ICC A117.1 Committee Action Report

Proposal list to the 2017 A117.1 for the 2023 edition –
2-24-2022 through 1-19-2023
Chapter 1 to 5

**FIGURE 503.3(A)
PASSENGER LOADING ZONE ACCESS AISLE - NEW BUILDINGS**

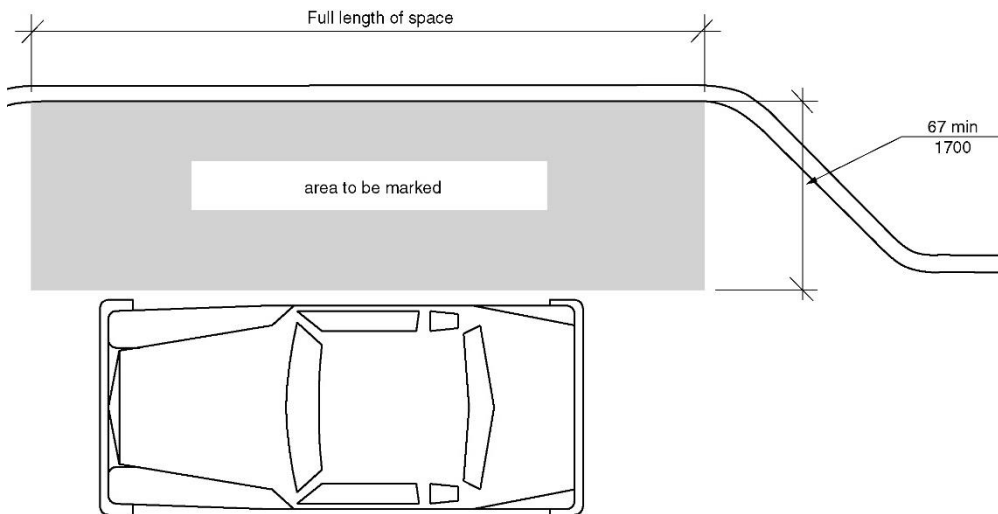
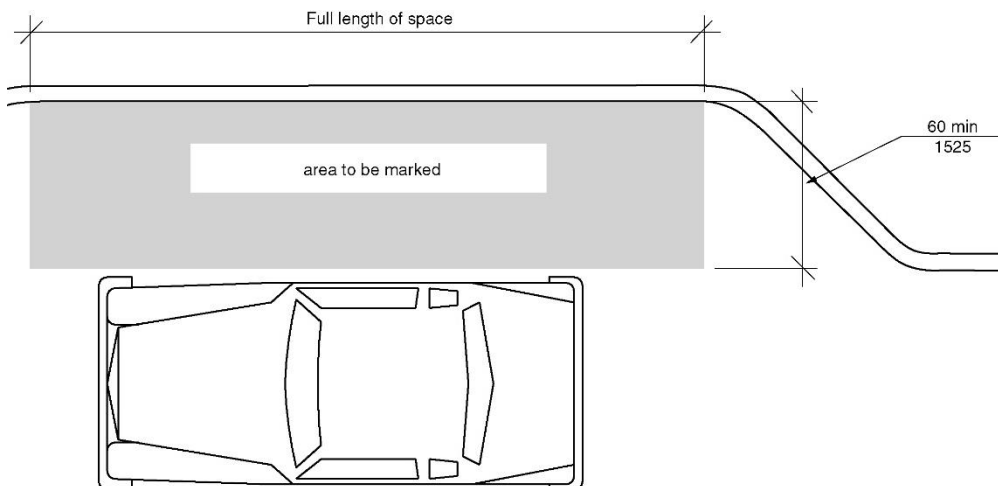
Note: Add curb ramps
